Responses to NRC Letter Dated July 17, 1998  
Request for Additional Information on the Reclamation Plan for the White Mesa  
Uranium Mill

Source Material License SUA-1358  
Docket No. 40-8681

Re: White Mesa Uranium Mill  
Response to NRC's Questions Dated July 17, 1998  
Site Reclamation Plan

International Uranium (USA) Corporation White Meso Mill		
EXISTING & PROPOSED SETTLEMENT MONITORS CELL 2 & 3 FIGURE 1 - ATTACHMENT 4		
DESIGN: RWH	DRAWN:	SHEET 1 of 1
CHKD BY:	DATE: 8/17/88	
APP:	SCALE: 1" = 200'

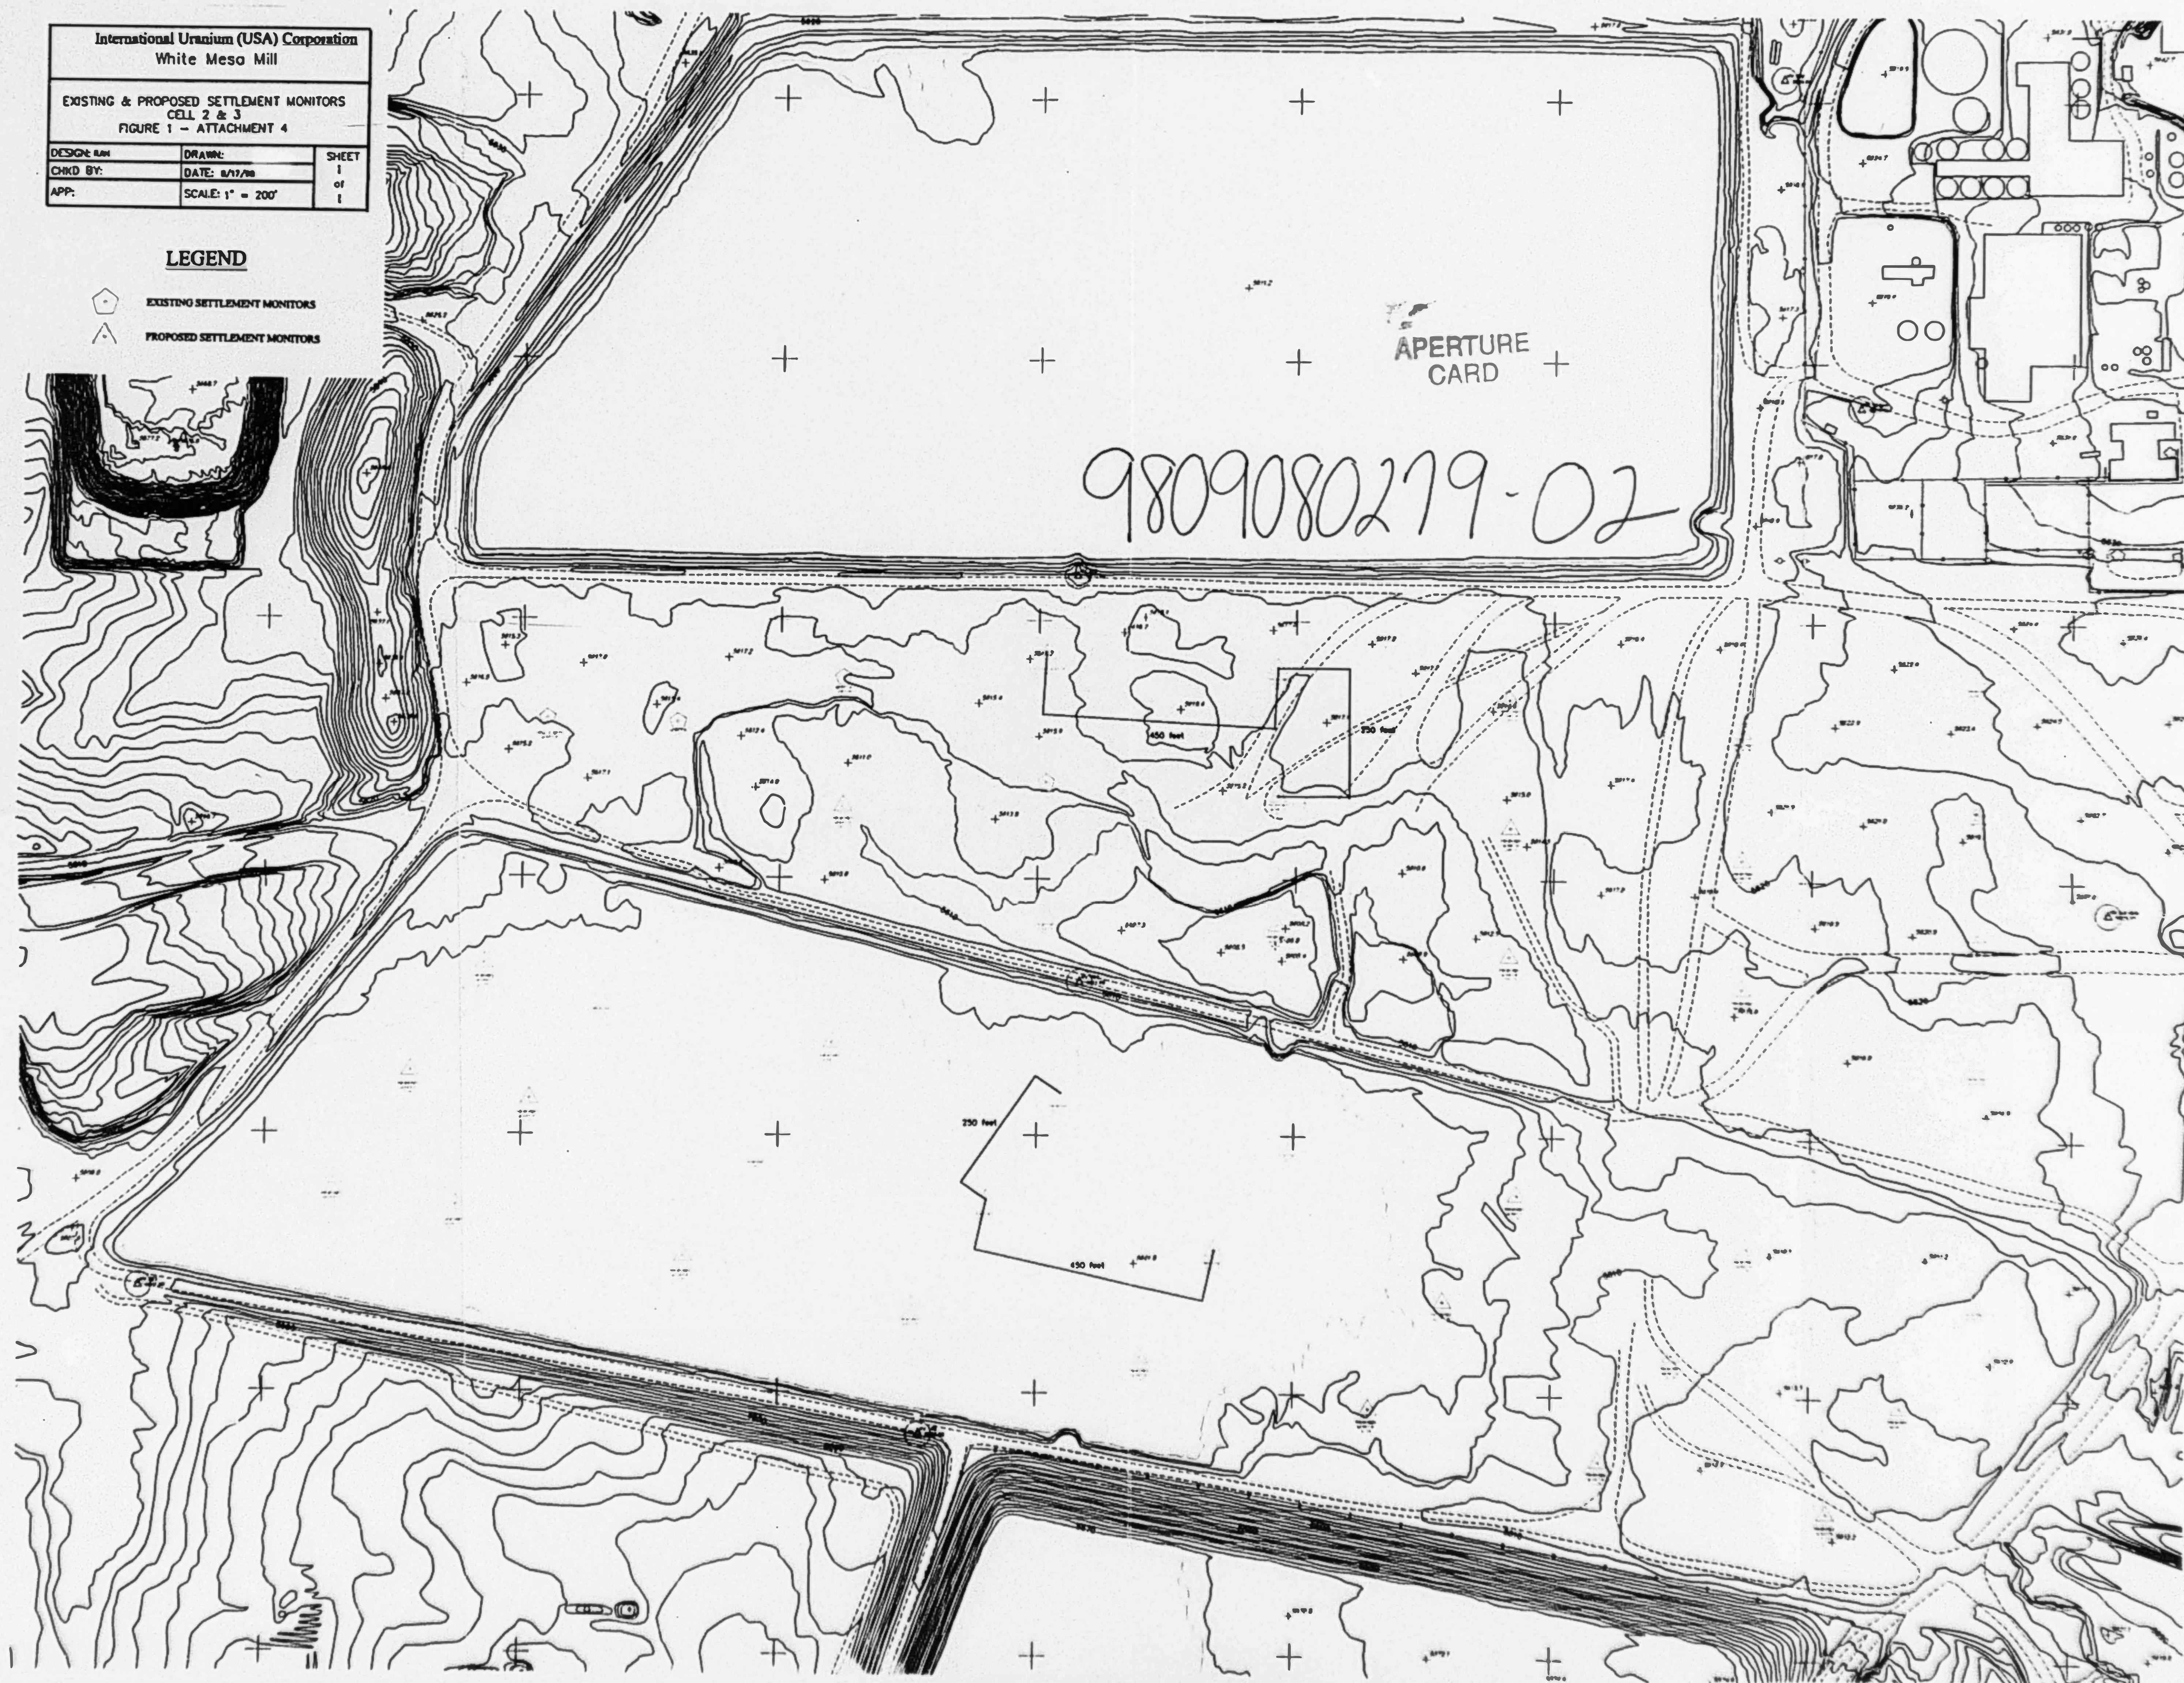
*A plan for settlement measurement that is satisfactory for producing representative settlement data throughout the disposal cells is required. Settlement measurement stations should be of sufficient coverage and should be strategically placed to yield adequate information for determination of differential and residual settlements. Monitoring monuments should be designed to be durable.*

Figure 1 of Attachment 4 shows the location of existing and proposed settlement monitoring locations on existing Cells 2 and 3.

Settlement monitors are monitored on a monthly basis utilizing standard surveying practices for vertical control. All elevations are referenced to an established benchmark located on solid ground away from the tailings cells. Settlement for each point is tracked utilizing a spreadsheet program and graphs. Figure 2 of Attachment 4 represents the design of the settlement monitors.

FIGURE 1  
ATTACHMENT 12

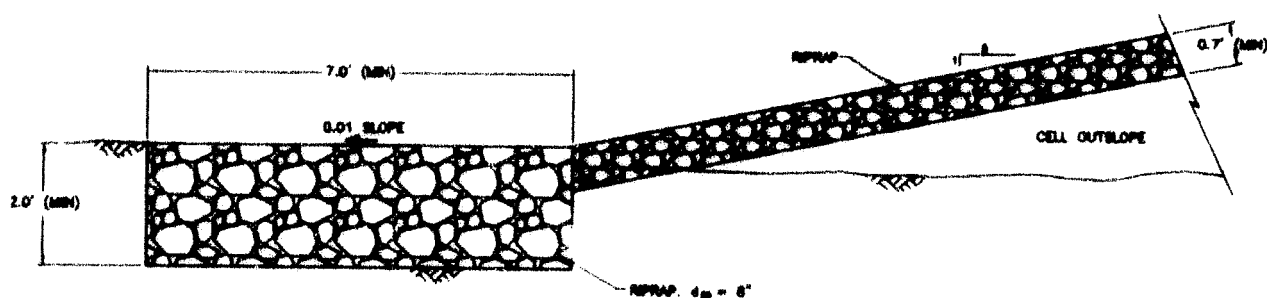
*Additional information and analyses are needed to show that the breached area of Cell No. 4A is protected adequately from erosion.*

Attached is a drawing (Figure 4 – Attachment 12) showing a plan view and cross section of a typical rock apron at the toe of cell #3 outslope. The apron is at least 7.0 feet wide and 2.0 feet thick with a surface slope of 0.01 ft/ft, and the  $d_{50}$  of the rock in the apron is 8.0 inches. The depth of scour in the sand soil predicted under PMP is 1.3 feet, so the apron thickness is greater than the scour depth. If bedrock is encountered at less than this depth, the key will be taken only to the top of rock. The calculations of rock sizes needed to resist erosion and the scour depth at the edge of the rock apron are included in table form with this response (Attachment 12).
